Addendum No. 1

IFB-25-00072

Progress Village Fire Station No. 48

**Addendum No. 1
FOR
CONSTRUCTION
OF
PROGRESS VILLAGE SOUTH FIRE STATION No. 48**

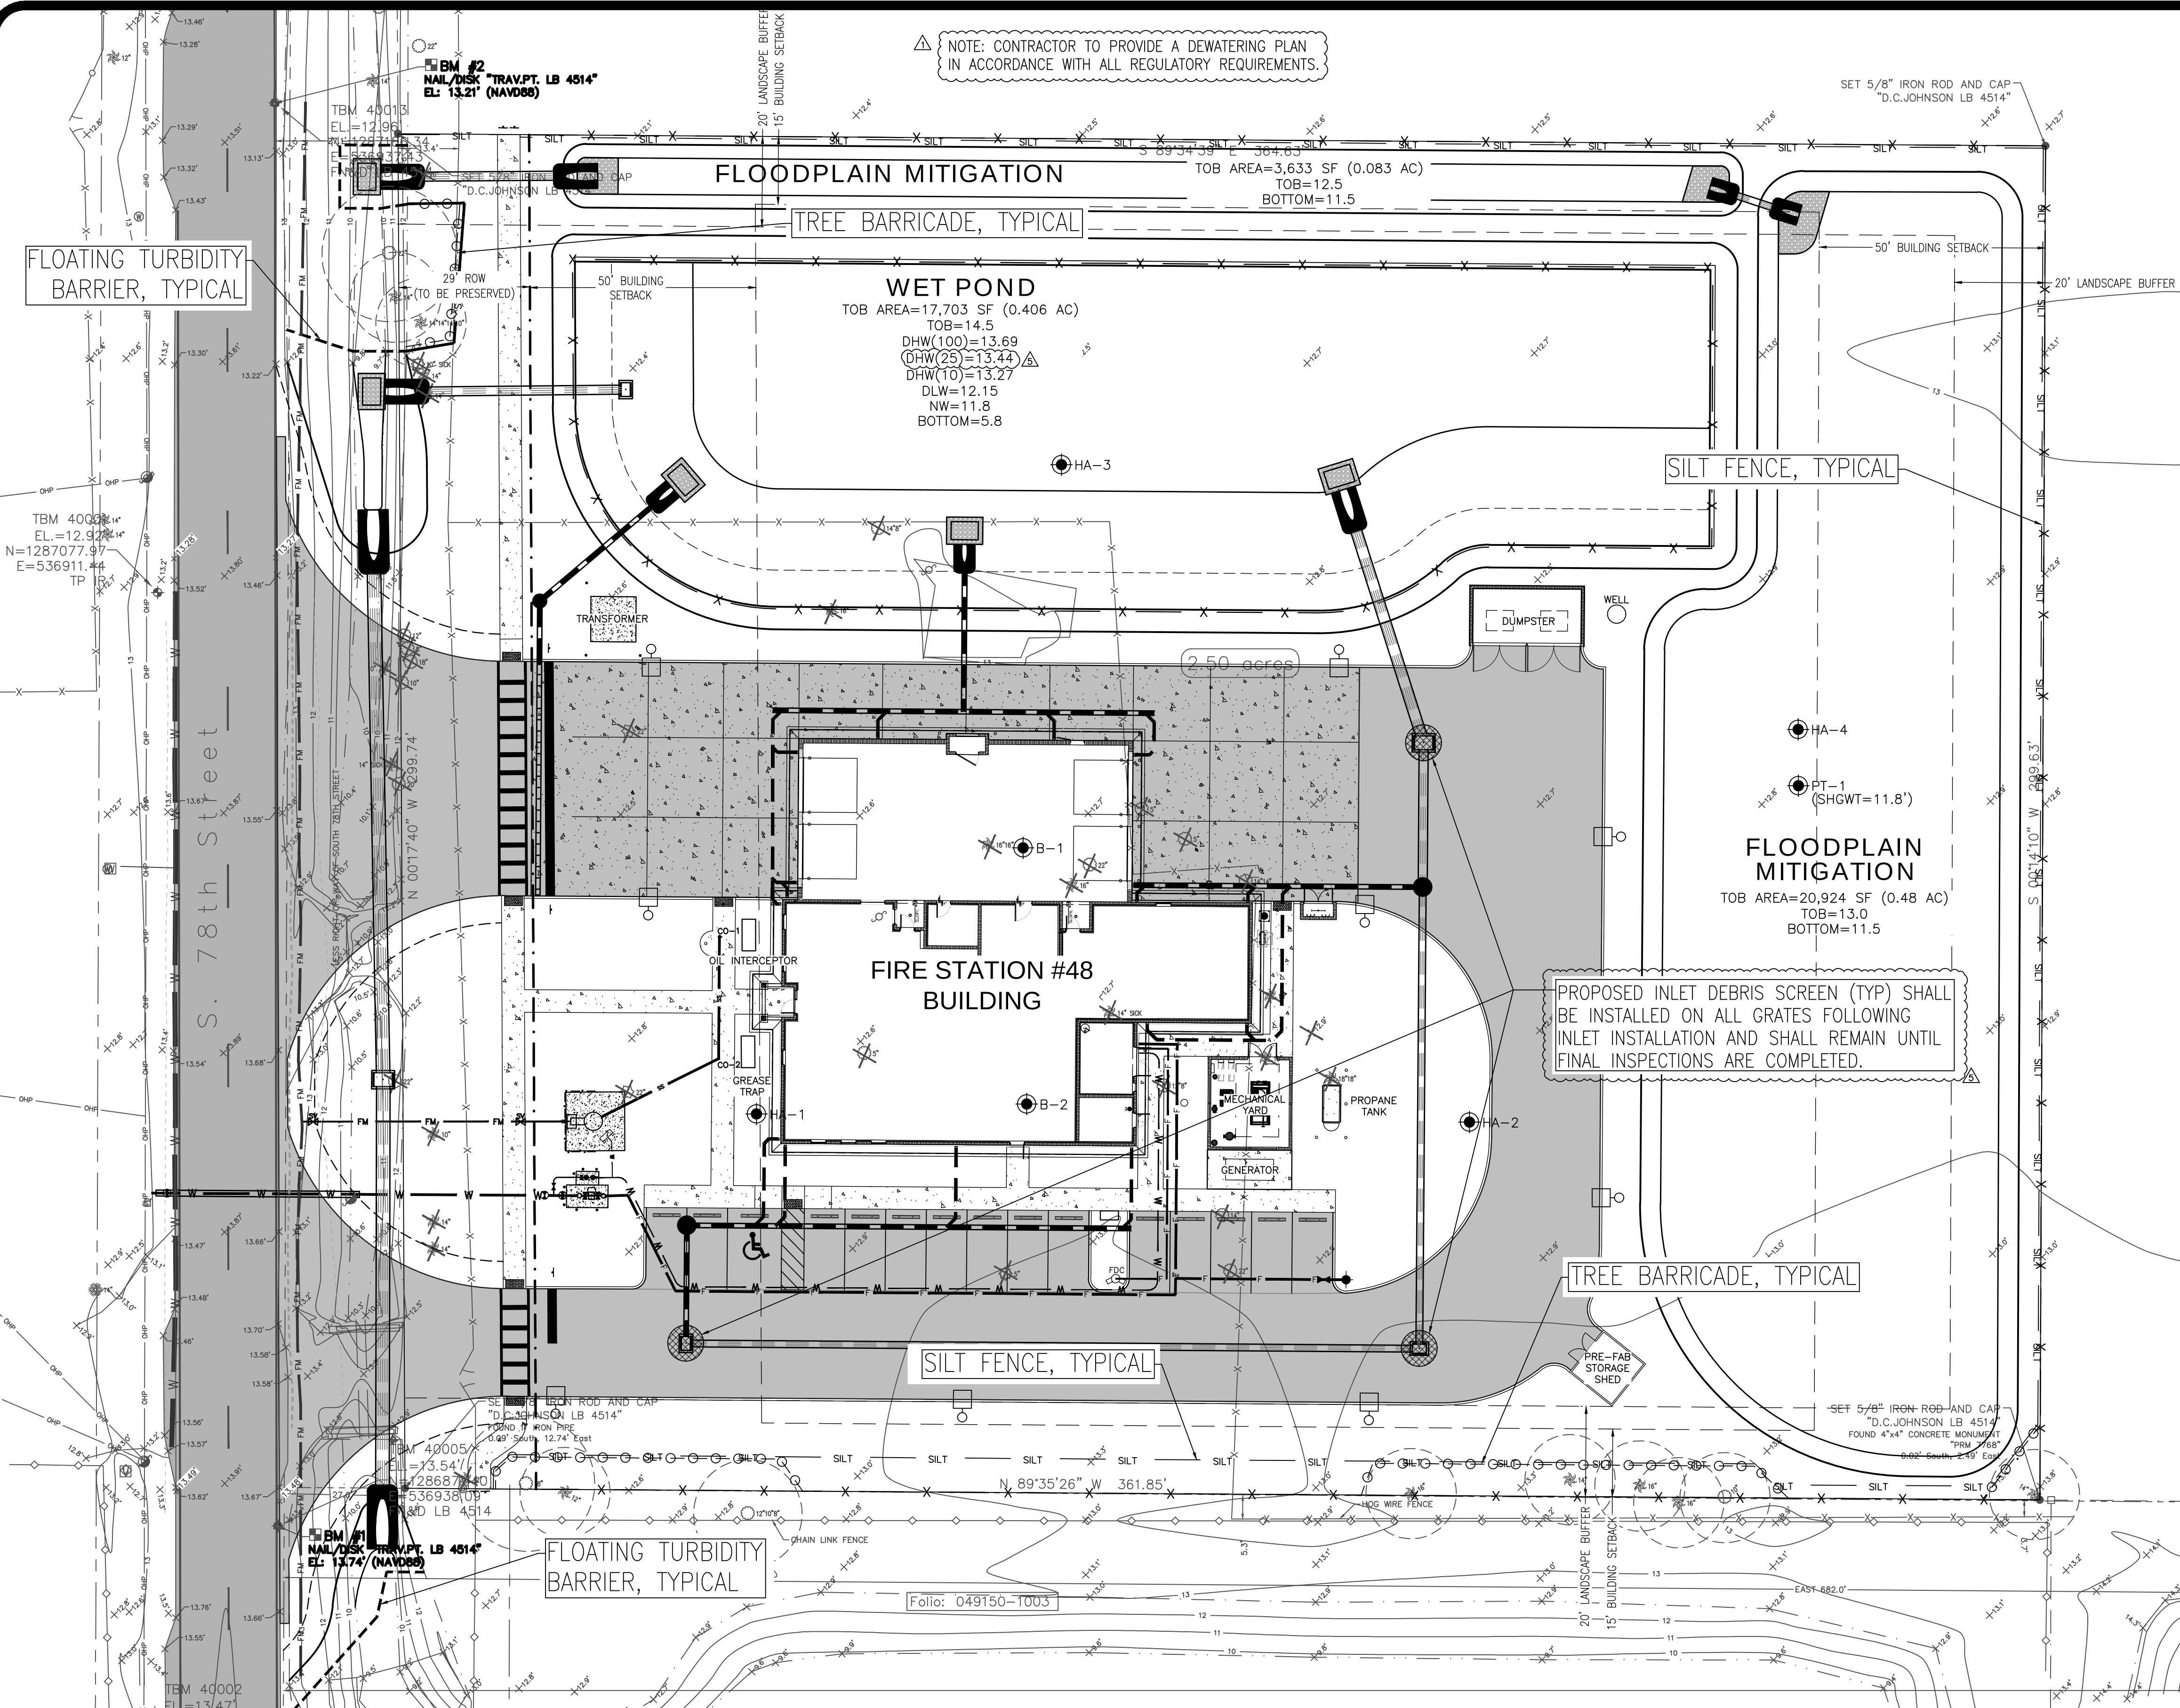
Question No.3: The civil sheets in the provided drawings are not able to scale correctly. Can new civil sheets with corrected scale be provided?

Response: Refer to attached revised C1.3 Civil Plans with scaled revised.

SCHEDULES AND DOOR AND WINDOWS TYPES

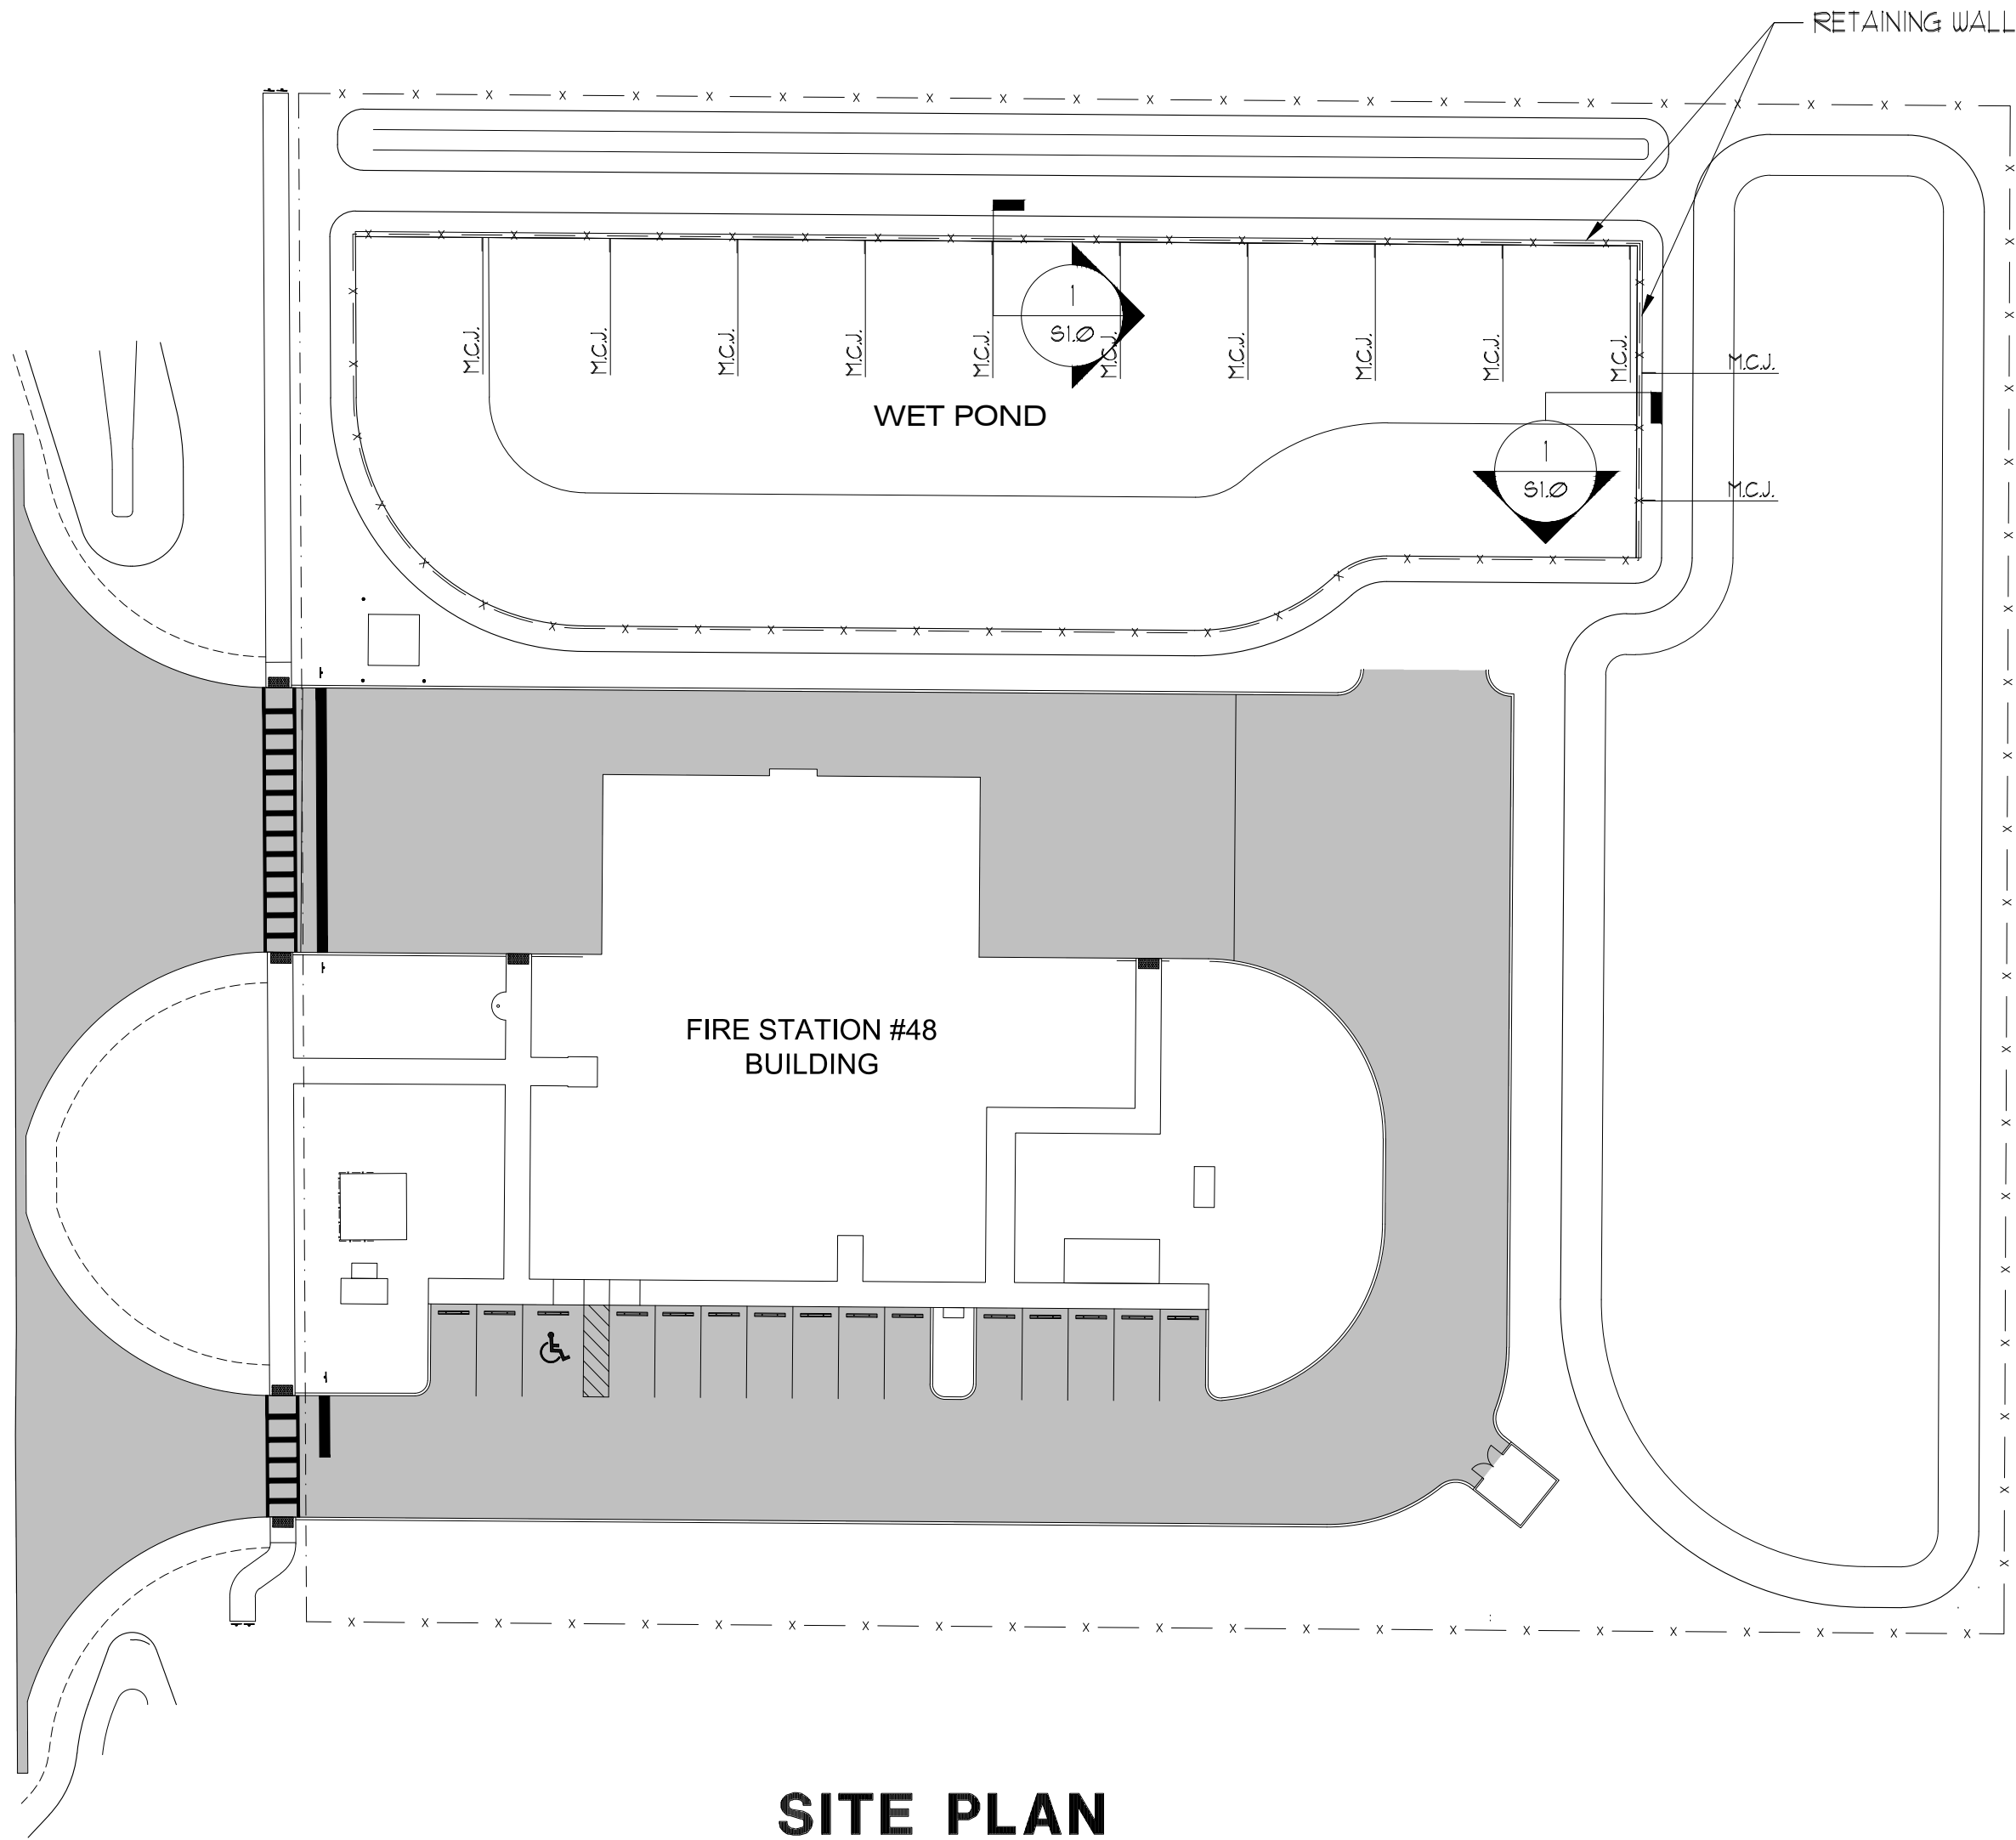
Question No.29: Please clarify whether the polished concrete is to receive color dye. Color dye is mentioned in the products section of the specifications, but not on the plans, nor in the execution section of the specs.

Question No.87: Reference sheet A7.1. The finish schedule on A7.1 indicates fiberglass reinforced plastic (FRP) at walls. Specifications for FRP wall panels are not included. Please provide.

Response: Delete the requirement for polished concrete flooring. Delete spec section 03 3600. Refer to revised finish schedules on sheet A7.1. Where scheduled in revised finish schedule (LVT), provide LVT by Shaw Contract Modern Edit - Intricate Alabaster 92100, Size: 12" x 24". This is a BASIS OF DESIGN product. Install in conformance with manufacturer's recommendations and requirements. Provide all accessories product required for a complete installation. Install in a Stagger pattern.

25. Replace sheet A5.1 ROOF DETAILS with dated 03.06.2025
26. Replace sheet A5.3 DETAILS with dated 03.06.2025
27. Replace sheet A7.1 SCHEDULES AND DOOR AND WINDOW TYPES with dated 03.06.2025
